TECHNICAL BULLETIN

206L-15-251

MODEL AFFECTED: 206L4

SUBJECT: CARBON FIBER INLET COWLING 407-064-004-101 / - 103, NUTPLATES 90-104CXX-X, REWORK OR REPLACEMENT OF.

Figure 1 - Nutplate Locations and Retaining Clip Detail

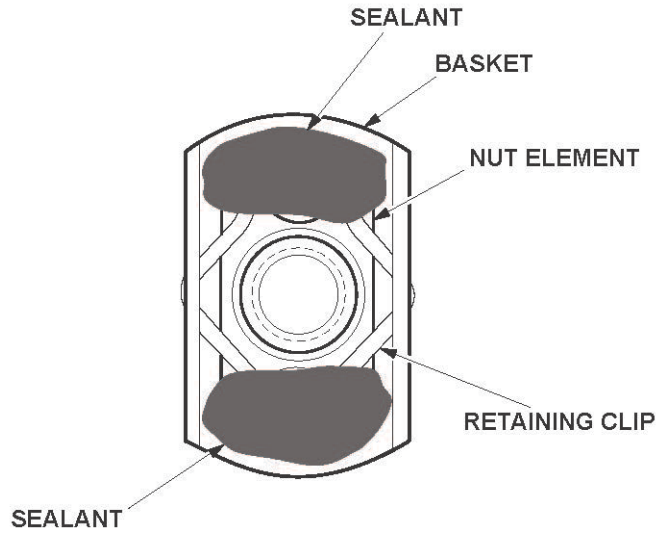
The cowlings are configured with **90-104Cxx-x** nutplates that are bonded on the inner surface. This type of nutplate is designed with a replaceable nut element that is held in place by a retaining clip.

PART I of this bulletin provides instructions to apply sealant to the nutplates to prevent a broken retaining clip migrating out of the nutplate.

1. Prepare the helicopter for maintenance.
 - a. Remove the air inlet cowl assembly (BHT-206L4-MM, Chapter 71).
2. If the nutplates (Figure 1, Detail B) are to be replaced, go to **PART II**.
 - a. Apply sealant to the nutplate basket and retaining clips (Figure 2).
 - b. Let sealant cure (BHT-ALL-SRM, Appendix A).
3. Install the inlet cowl assembly (BHT-206L4-MM, Chapter 71).
4. Make an entry in the helicopter logbook and historical service records indicating compliance with **PART I** of this Technical Bulletin.
